Drain: OAK TREE DRAIN **Drain #:** 209
Improvement/Arm: STATION - STRIKELEATHER RELOCATION
Operator: JDH **Date:** 3-23-04
Drain Classification: Urban/Rural **Year Installed:** 1999

Re: Oak Tree Drain

Re: OakTree Drain: Staton-Strikeleather Reloc.

POND DEVELOPMENT
MICHAEL STIKELATHER RELOC. OF OAK TREE DRAIN
PART OF SW 1/4 OF SEC. 32, T18N, R3E
CLAY TOWNSHIP, HAMILTON CO., IN

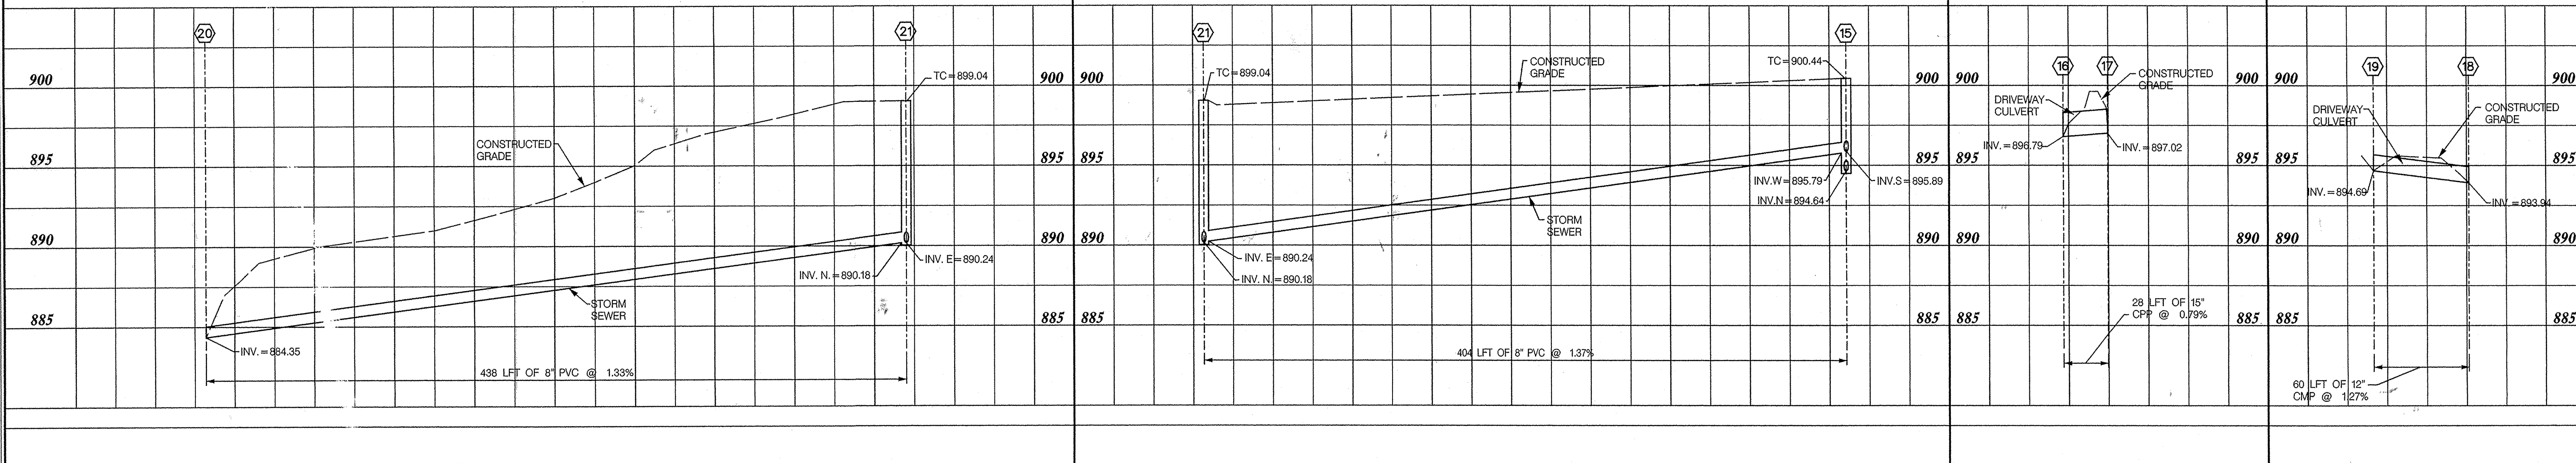
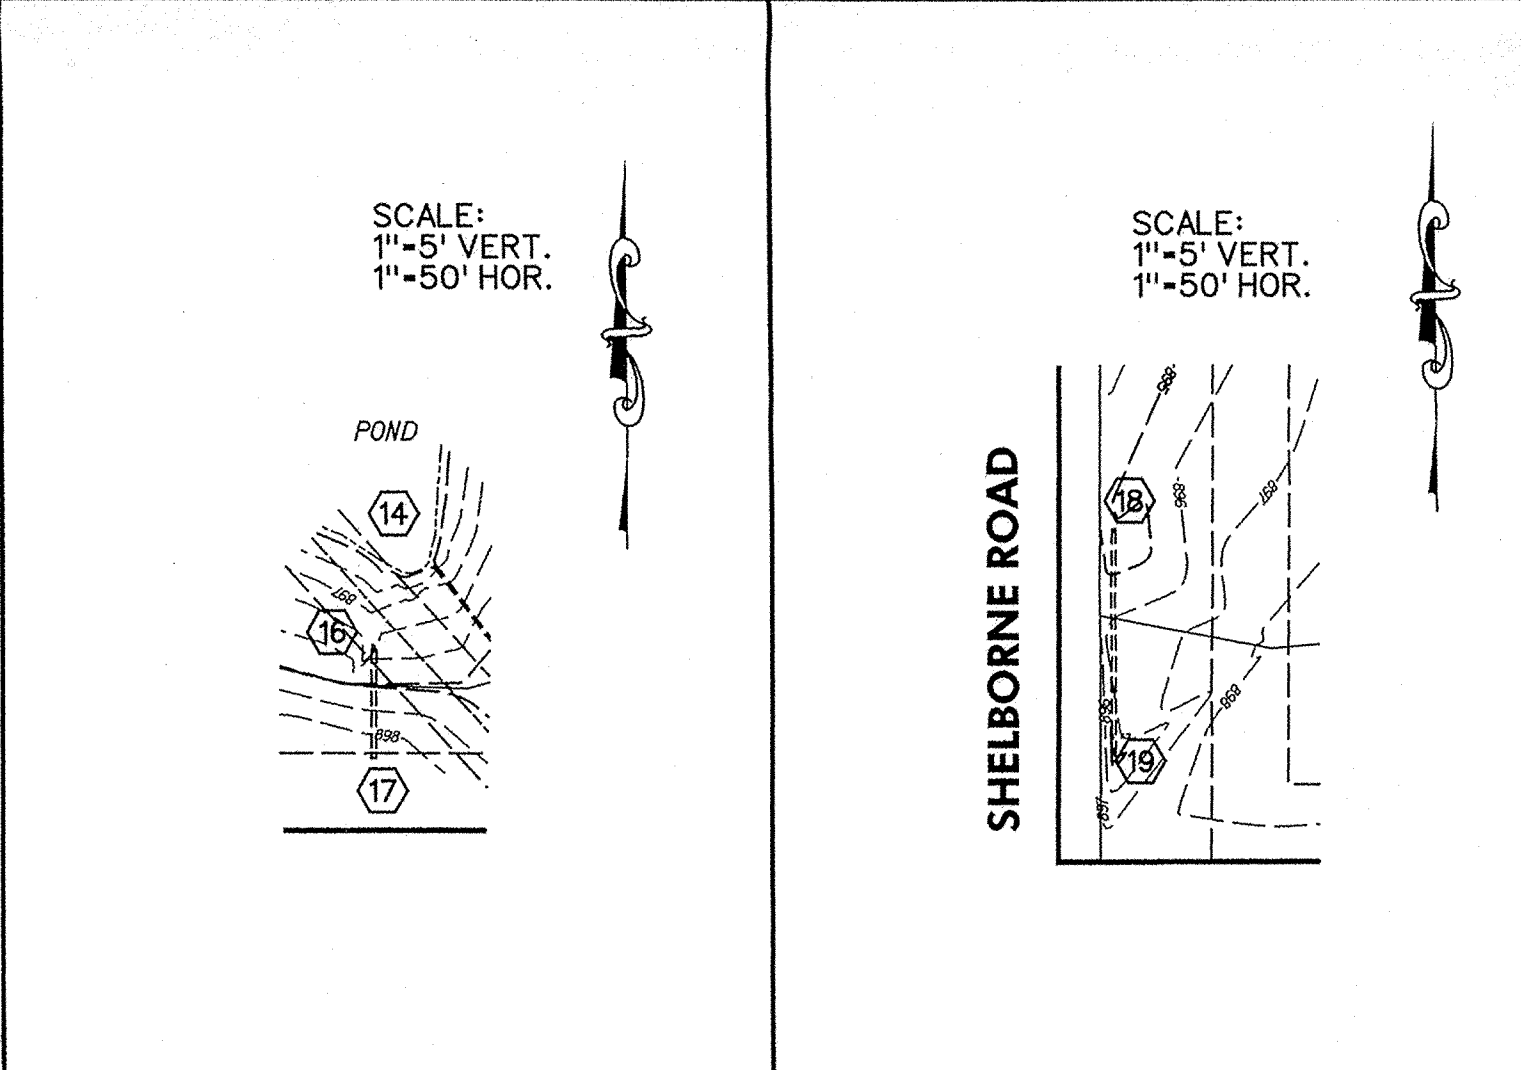
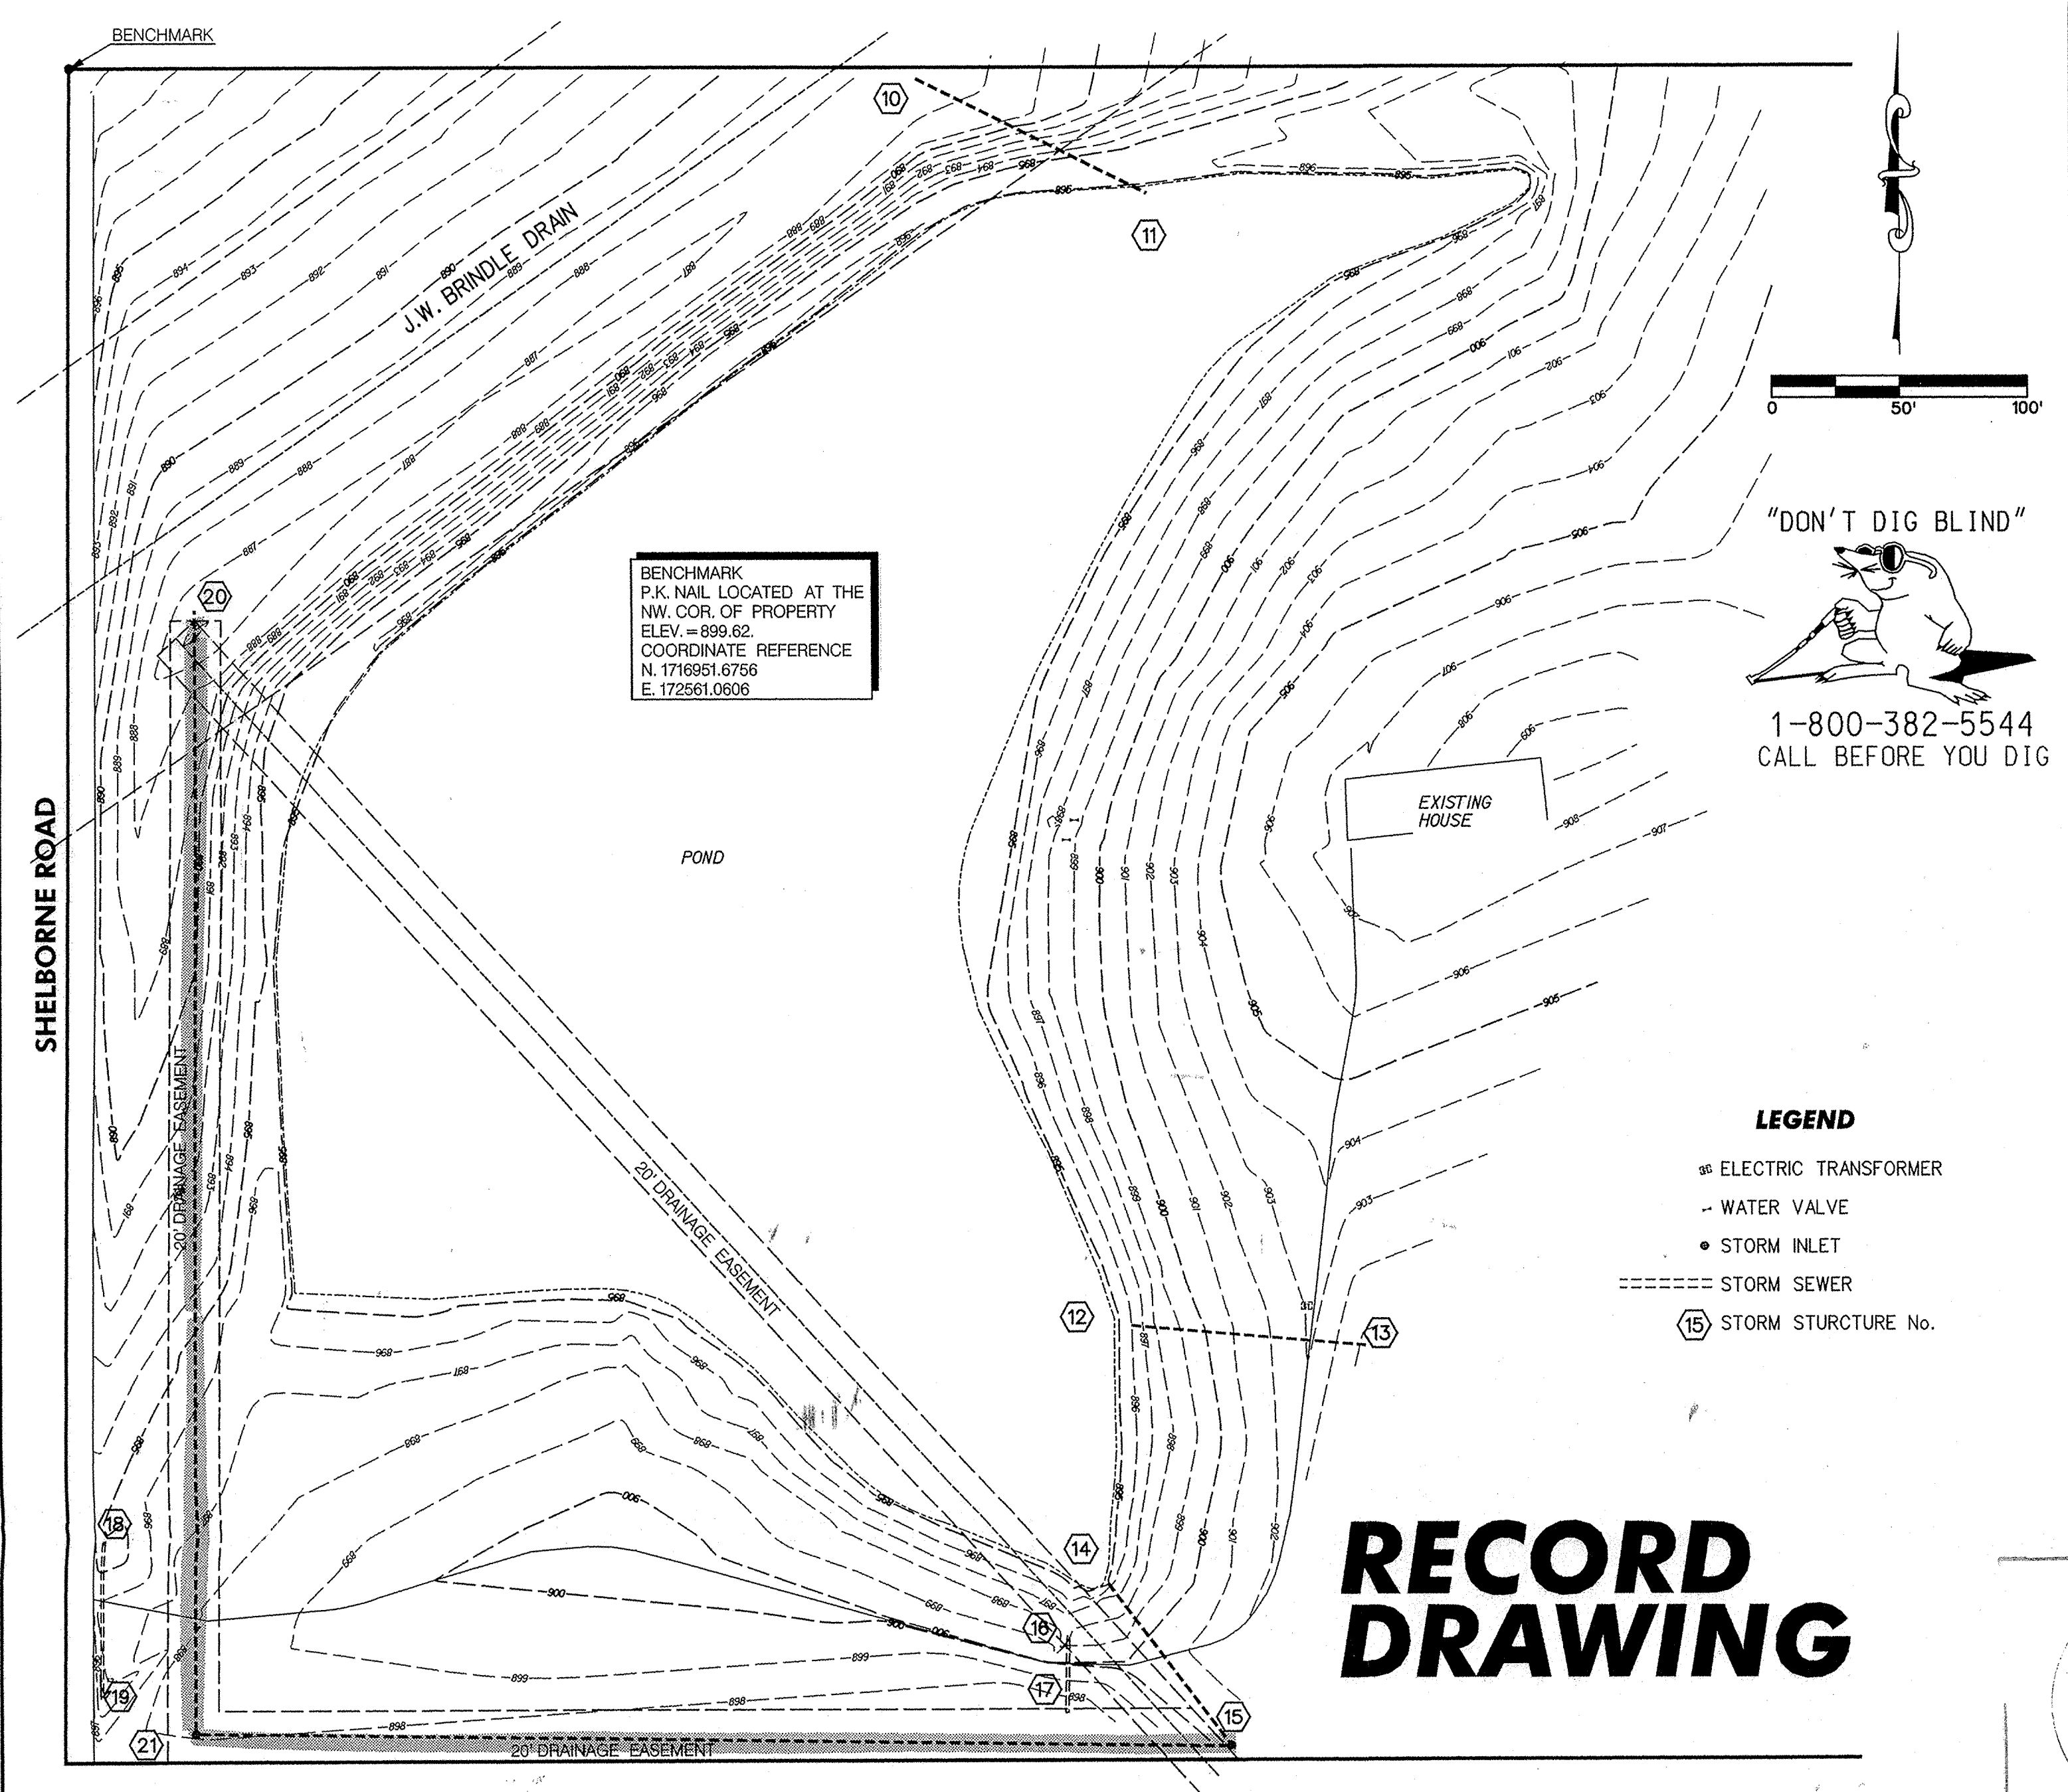
During construction, changes were made to the drain which will alter the plans submitted with my report for this drain dated April 19, 1996. The changes are as follows:

Structure: T.C.: I.E.: Pipe: Length: Original Plans: Difference:

20		884.35				
21	899.04	890.18	8	438	430	8
21	899.04	890.24				
15	900.44	895.79	8	404	400	4

The length of the drain due to the changes described above is now **842 feet**.
